Access Compliance Report

Public Rights-of-Way

(Curb Ramps)

Intersection ID: N/A	Main Street: MATTHEWS_FARM_LN	Cross Street: WOODBINE_WALK_RD	Location: NE
ADA ID: 8781093BFF4B	Ramp Type: Directional1	Initial Pass/Fail: Fail	Overall Compliance: No
Severity Score: 1.25			
Codes/Mitigation Info/Possible Solution		Field Measurements/Component Compliance

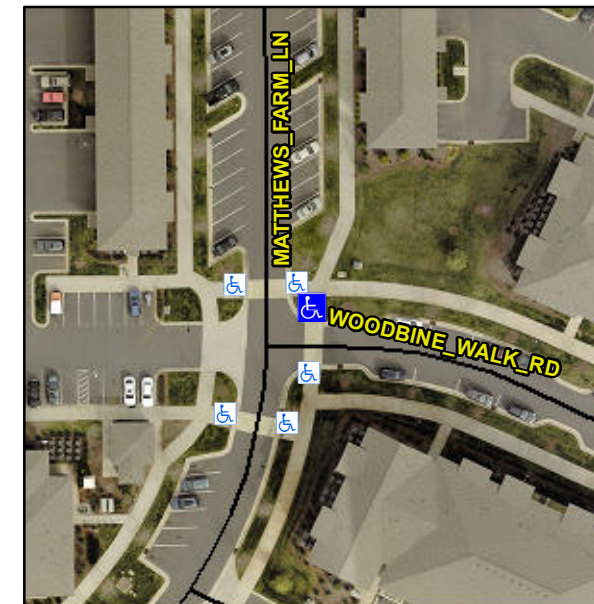
PROW/ADA:

R304.5.3

Possible Solutions:

Remove & Replace Entire Ramp.
